Re: Terminal Building Remodel & Expansion  
Aberdeen Regional Airport  
Aberdeen, South Dakota  
A.I.P. #3-46-0001-055-2025  
A-9799

**ADDENDUM NUMBER 1**

ADDENDUM NO. 1  
TO GENERAL, MECHANICAL AND ELECTRICAL  
ABERDEEN REGIONAL AIRPORT  
TERMINAL BUILDING REMODEL & EXPANSION  
ABERDEEN, SOUTH DAKOTA

**Date:** May 16, 2025**Project:** Aberdeen Regional Airport Baggage Addition**To:** Dean Marske, AIA  
HKG Architects**Project #:** BS25017**From:** Jon Kennedy, PE  
Stu Oster, PE**Project Location:** Aberdeen, SD**Addendum Number:** No. 1

1 POWER AND COMMUNICATIONS PLAN - FIRST FLOOR  
1/4" = 1'-0"

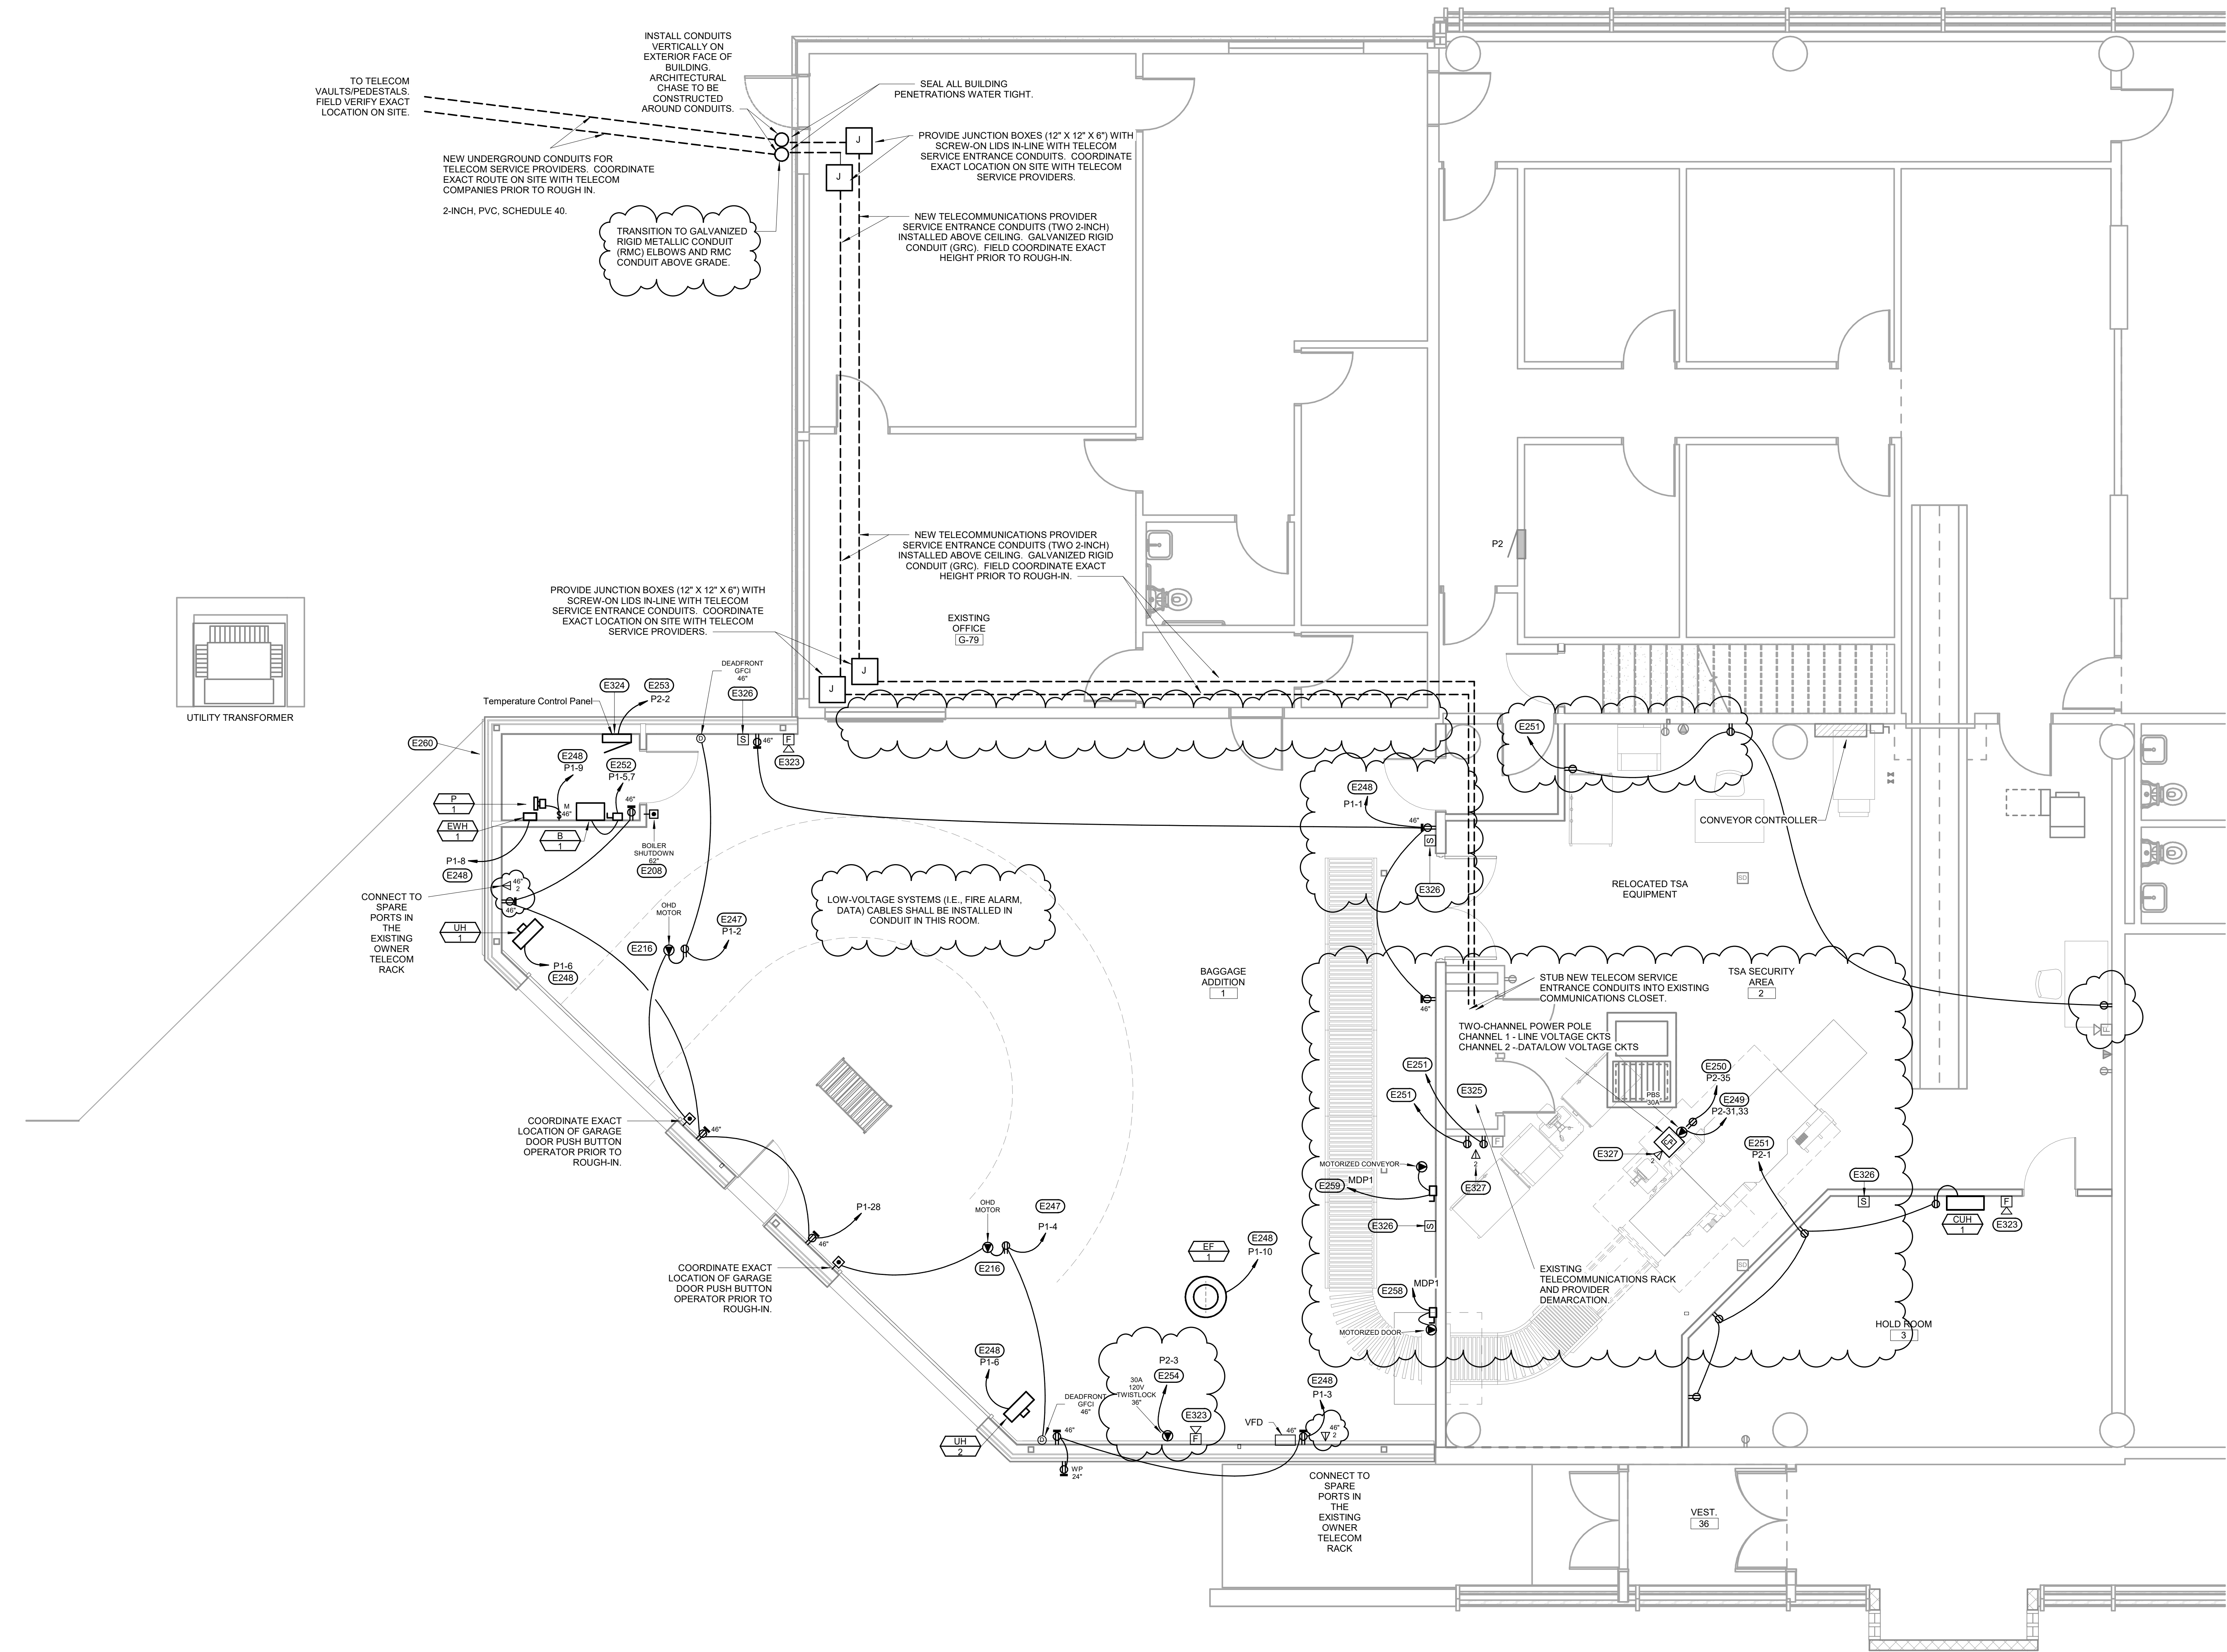
**Sheet E2 – Power and Communications Floor Plan**

1. Connection to Pump P-1 (circuit P1-9) and connection to Boiler B-1 (P1-5,7) along with the boiler shutdown switch shall be provided under scope of Alternate Bid B1 only.
2. Refer to the attached floor plan for receptacle location revisions.

1 LIGHTING FLOOR PLAN  
1/4" = 1'-0"

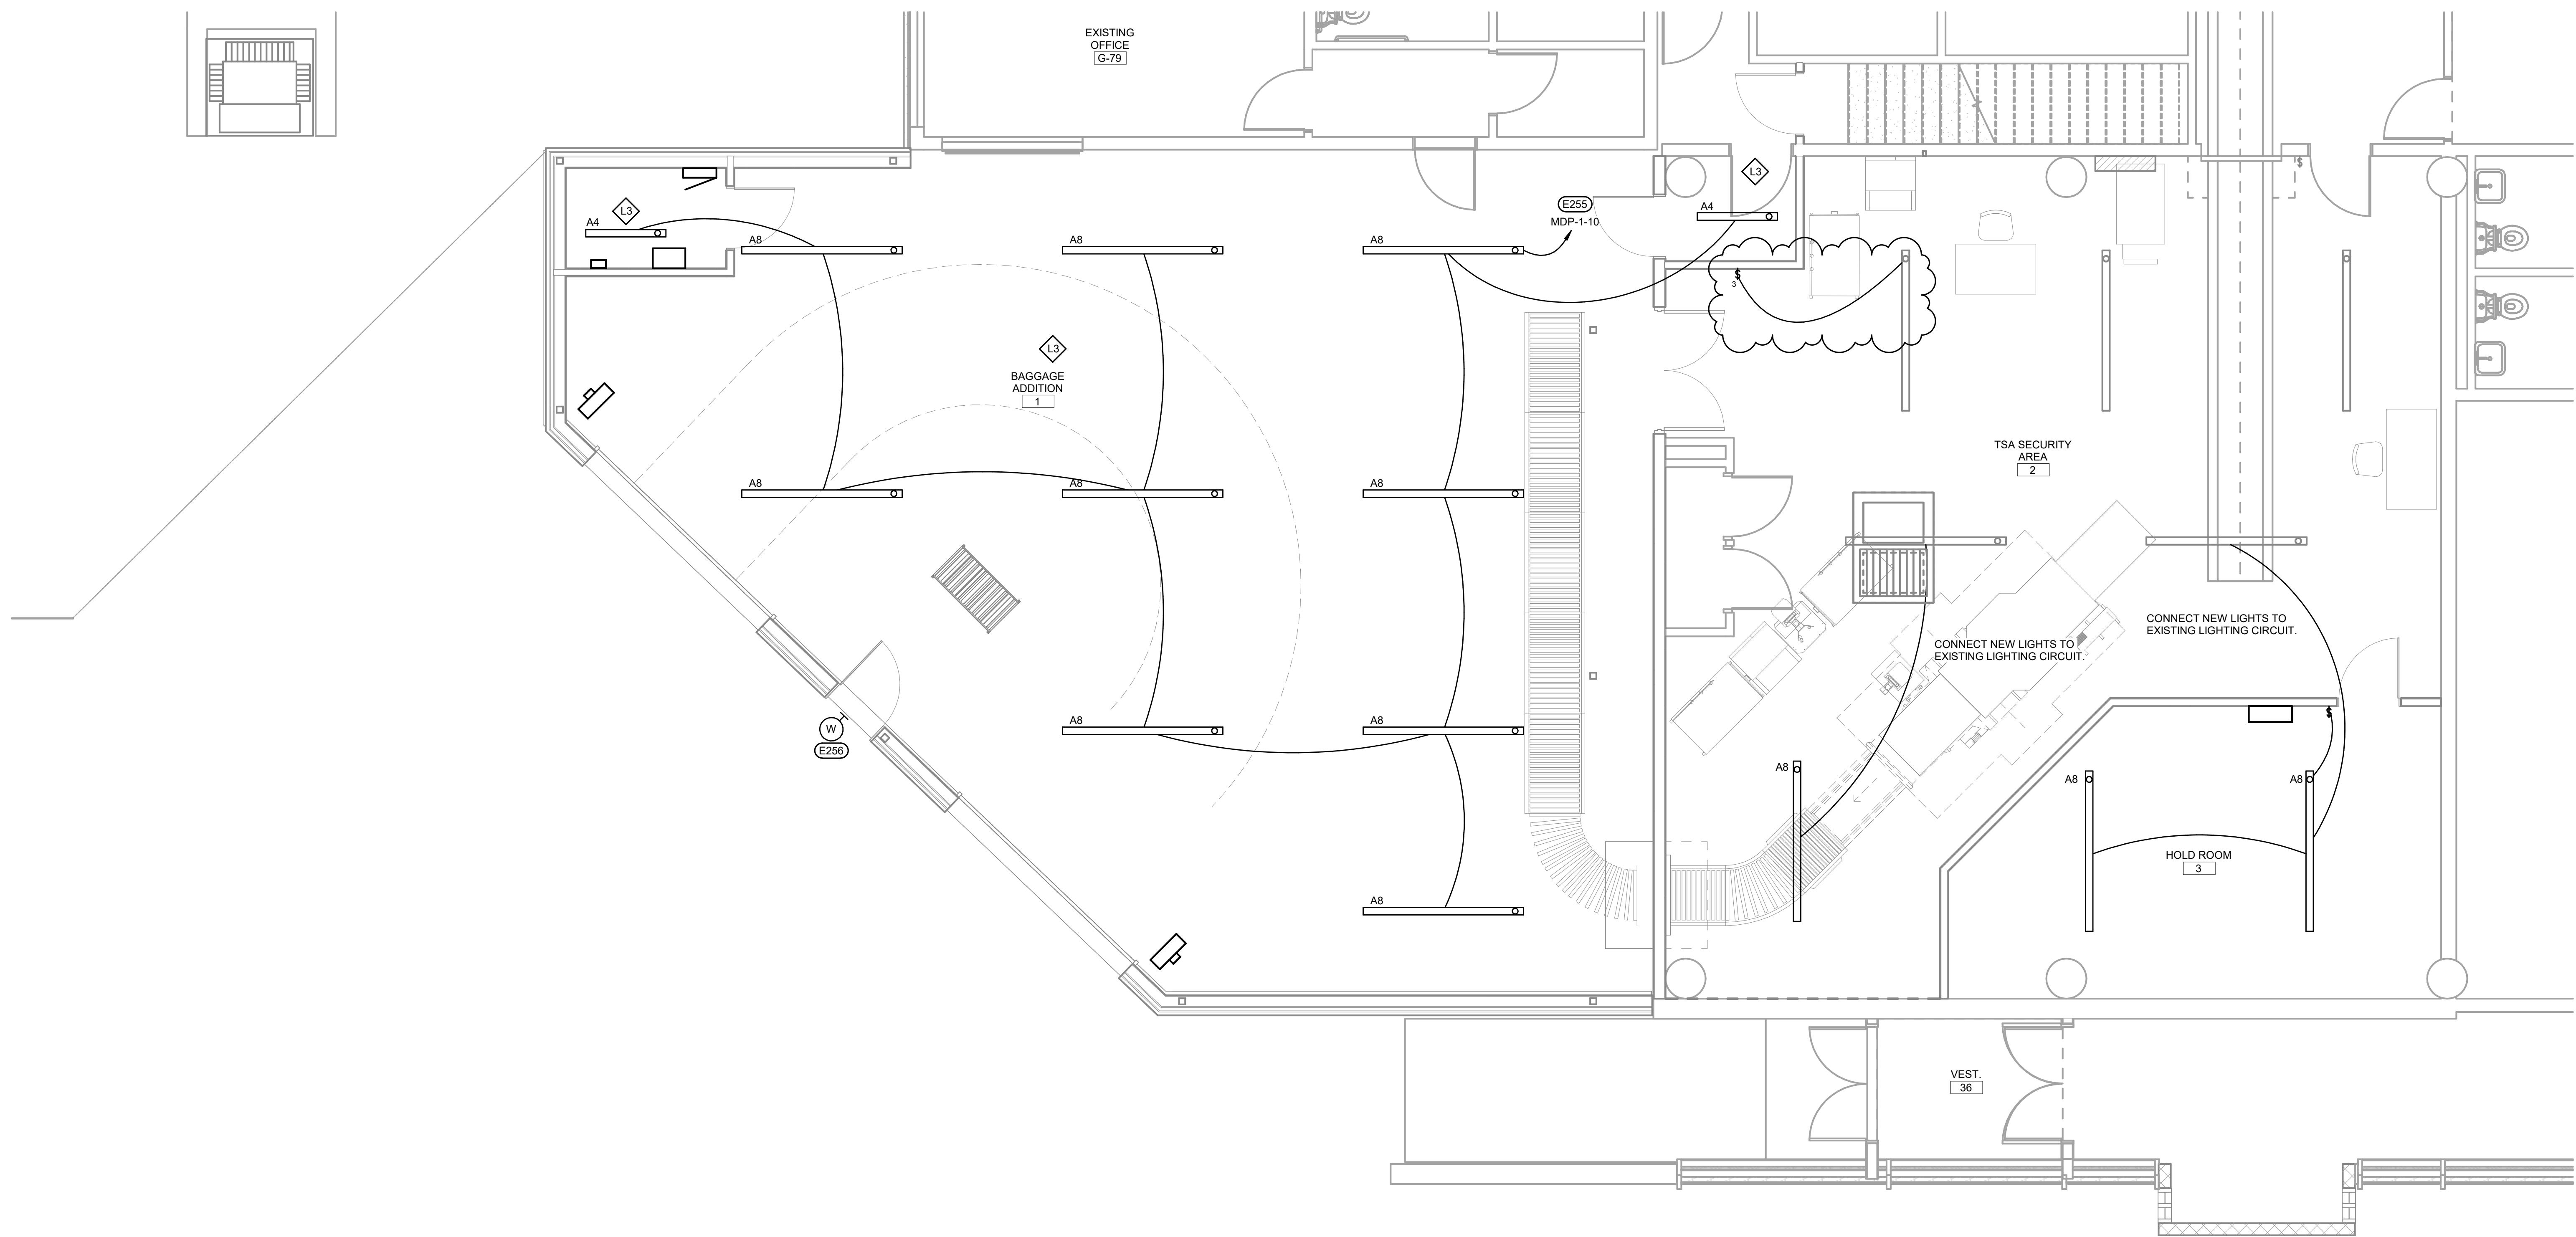
**Sheet E3 – Lighting Floor Plan**

1. Lighting control sequence of operations added. Reference attached drawing.
2. Light switching in TSA Security Area 2 changed. See attached drawing for revisions.
